**Re. Response to Council further information requests for the EB2 and EB3R Application Packages**

I am writing in regard to Auckland Council's (the Council) further information request letter of 9 September 2022 for the Eastern Busway 2 (EB2) and Eastern Busway 3 Residential (EB3R) application packages, as well as further correspondence received in regard to Industrial Trade Activities.

Figure 1: SIDRA model layout - Edgewater bus station midblock pedestrian crossing

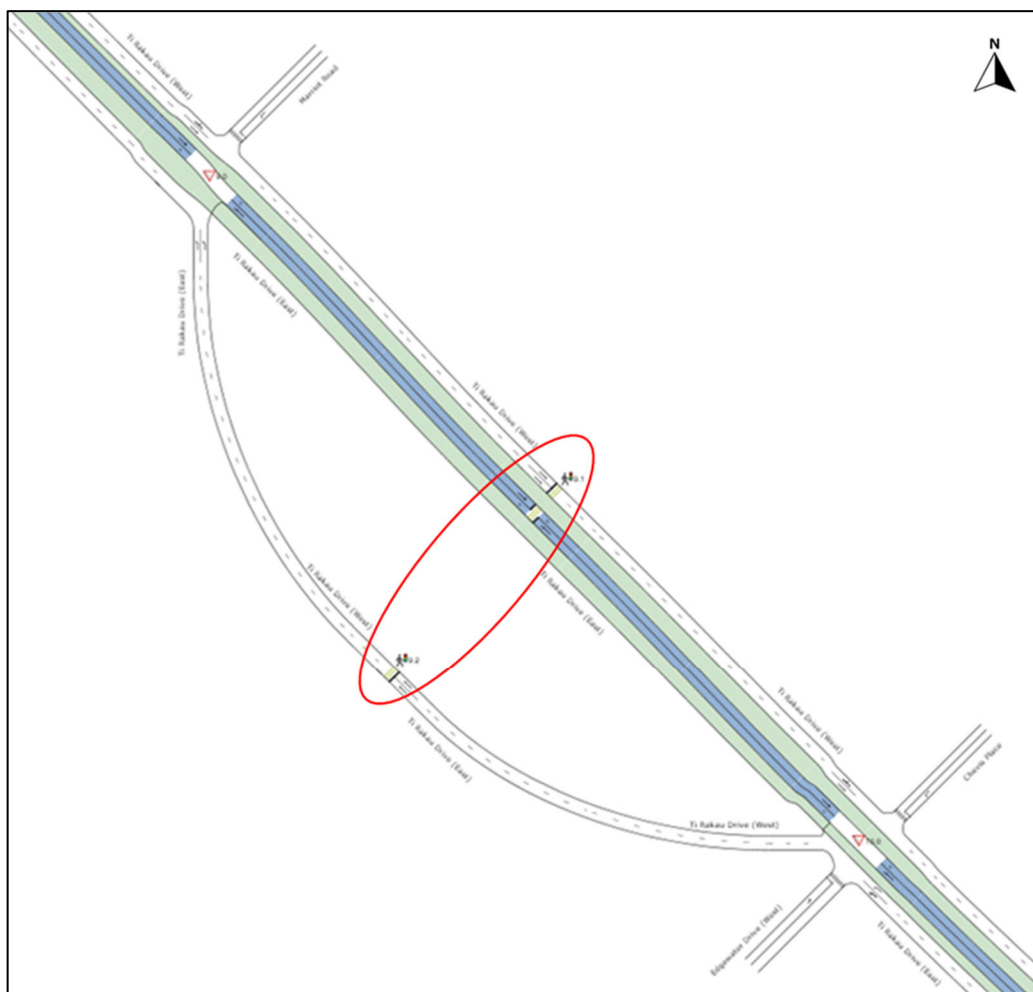
58. It is noted that the ITA includes relevant appendices to demonstrate phasing diagrams at different project stages. However, the 3-staged mid-block pedestrian crossing across Ti Rakau Drive between Marriott Road and Edgewater Drive has not been elaborated on. Please confirm how the intersections and associated phasing are expected to be operated, i.e., three standalone signalised crossings or staggered pairs?

A mid-block signalised pedestrian crossing will be provided across Ti Rakau Drive between Marriott Road and Edgewater Drive west, in proximity to the Edgewater bus station. The crossing will be a three-stage staggered signalised crossing, which will run across the two Ti Rakau Drive eastbound general traffic lanes, the two central dedicated bus lanes and the two Ti Rakau Drive westbound general traffic lanes.

Due to the limitations of the SIDRA traffic modelling software, which can only model at maximum a two-stage signalised crossing, the three-stage crossing was modelled as two separate intersections alongside each other.

The SIDRA model of the signalised crossing is shown in Figure 1, for the geometric layout of the signalised crossing refer to Appendix C in the ITA.
